**RES & EPRI Team Response to FAQ 06-0016**  
**NUREG/CR-6850, EPRI TR-1011989**

Final – 2/7/2007

**Subject:** Clarification/enhancement of Ignition Source counting guidance for Electrical Cabinets in NUREG/CR-6850, supporting NFPA-805 Fire PRA application.

Load Center or Unit Substation

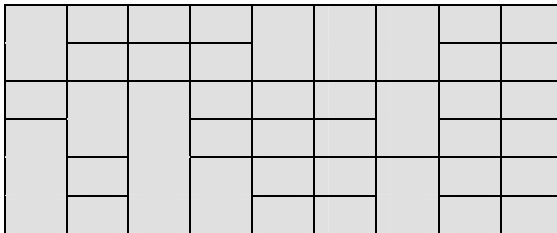
The team agrees in full with the three examples provided on Page 3 of the FAQ and their results (i.e., the switchgear, load center and MCC examples resulting in counts of 9, 4 and 9 vertical sections respectively).
